Product / Process Change Notification (PCN)

PCN #: PCN_UtLAN_20190226

Affected Series: WE-LAN

PCN Date: November 26, 2018

749013021

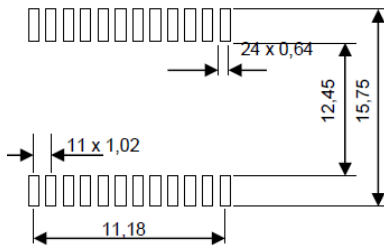
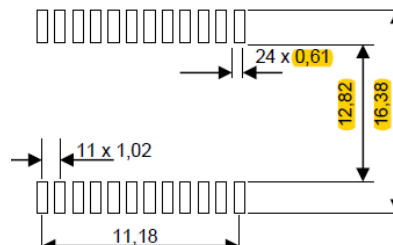
- Changes in land pattern.

749013022

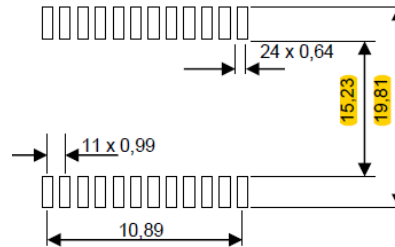
- Changes in land pattern.
